County Commission of Jefferson County
Rose Hill Subdivision – Site Work Project
(JCPC File No. 02-09)

6/25/2019	1. Fabric for Separation for Full Depth Excavation – 800 SY +/-

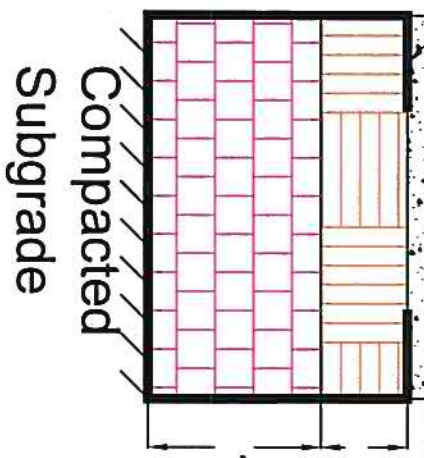
Separation Fabric
Geotextile
6" min overlap

2" Asphalt Wearing
Coarse
9" Base 1 Stone, 2 lifts
18" of #57 Stone

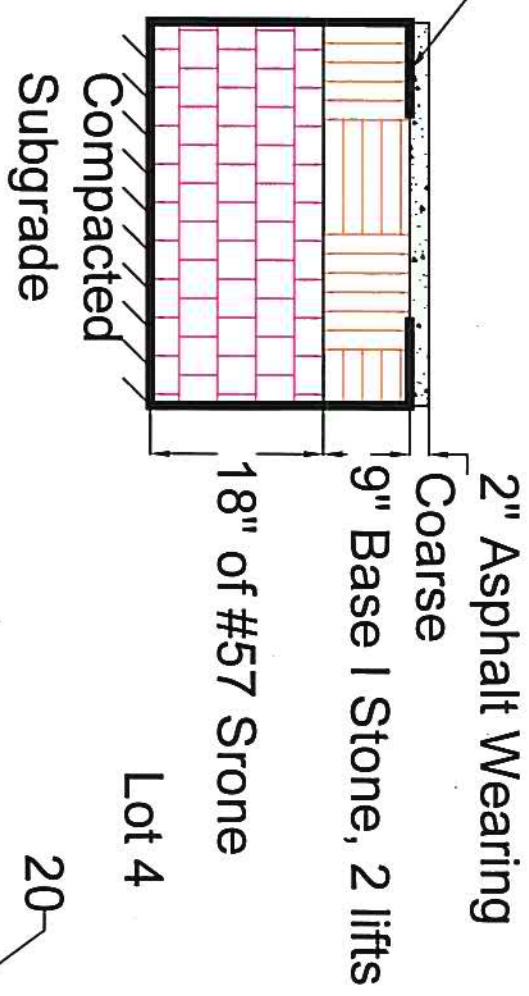
Separation Fabric
Geotextile
6" min overlap
